Job ID: 2012-07-4559-CH OF USE

has permission to Change of use from Truck Repair to Distillery with Interior Renovations.

Jonathan Rioux - Re: 101 Fox St.

From: W. Mark Cummings, P.E.
To: Mr. Luke Davidson; Davidson & Farber Distilleries
CC: Capt. Chris Pirone; Fire Prevention Division, Portland Fire Department
Subject: **Fire Hazards Assessment of the Davidson & Farber Distilling Site at 101 Fox St., Portland, ME.**

STAIR SECTIONS
SCALE: 1" = 1'-0"

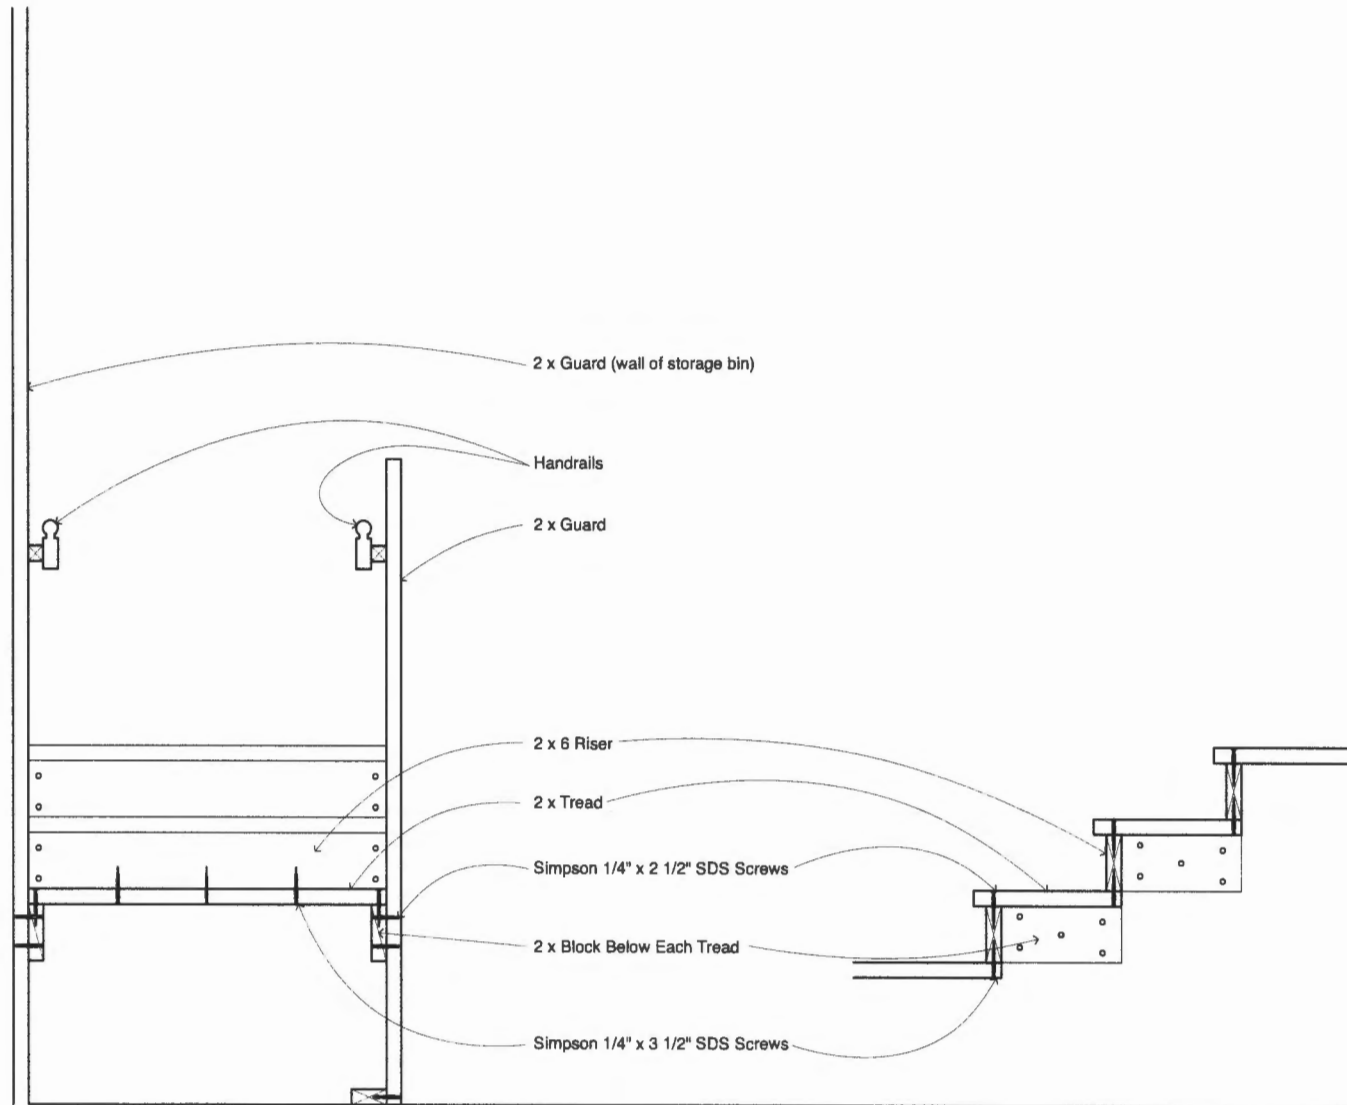
- Can you provide a cross-section/ specs. for the new stairwell to the mezzanine?

See attached sketch:

MEZZANINE LEVEL FLOOR PLAN

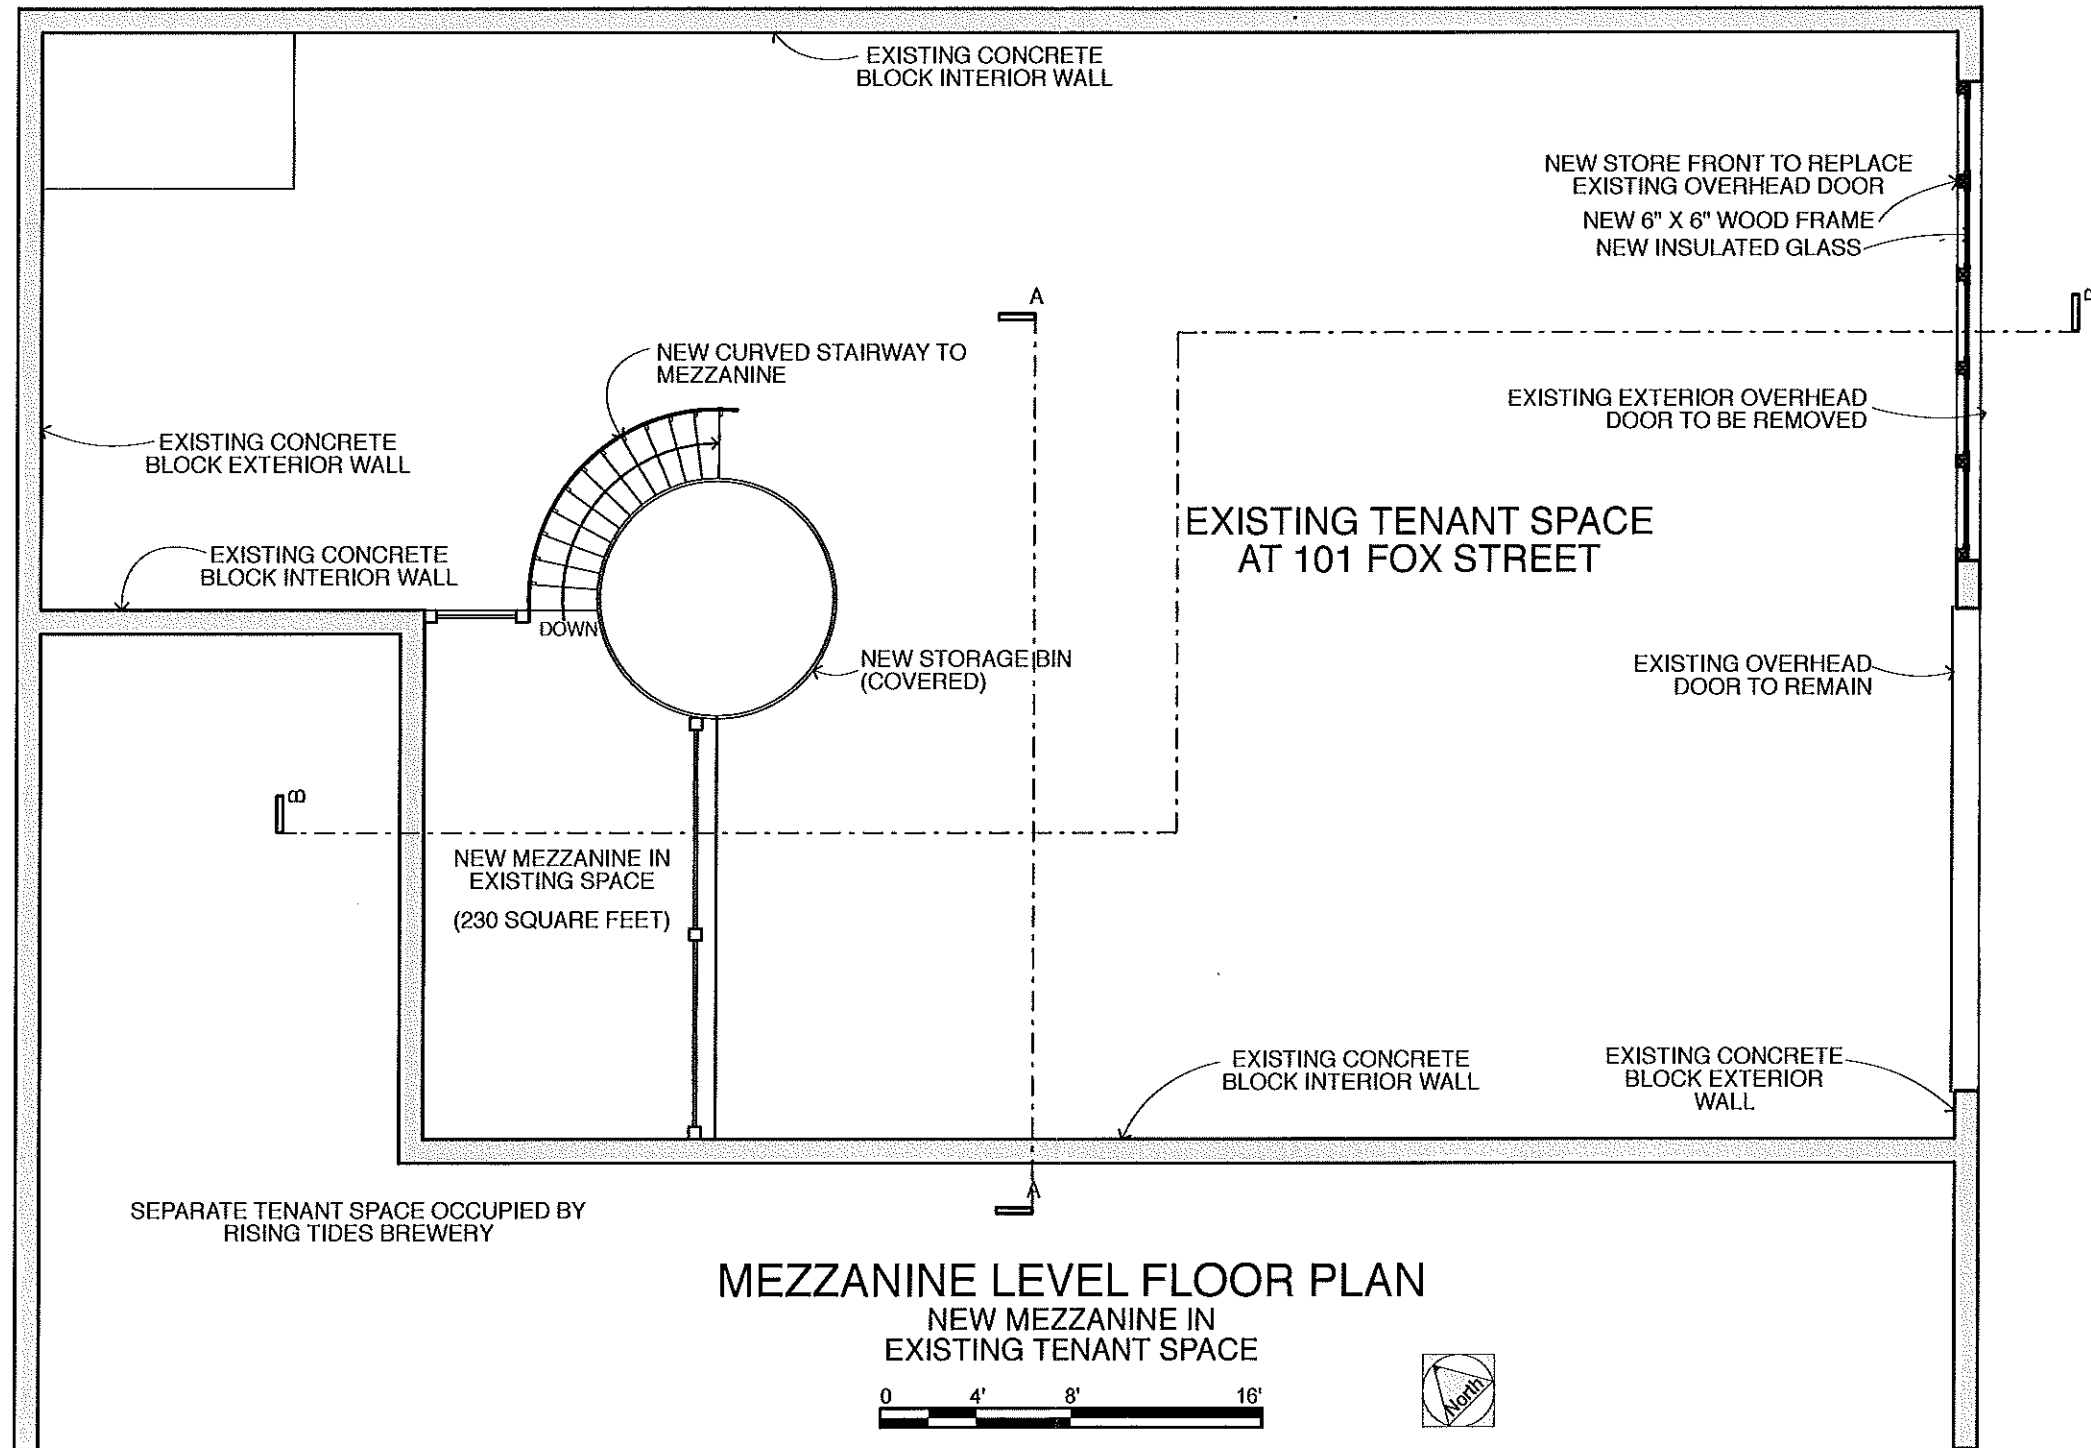
I spoke with owner Luke Davidson and he was going to speak with Engineer Mark Cummings to make sure we were all on the same page with the construction type or if we could have a fire protection under the 2x6 floor deck of the mezzanine. I'll remind Luke and copy Mark to be sure to get a response to you ASAP.

- Floor joist & Beam(s) type/ max spans and floor loads 1603.1.1?

3" x 8" hemlock beams at 24" o.c. with a span of 10'-6". 75psf uniform live load.
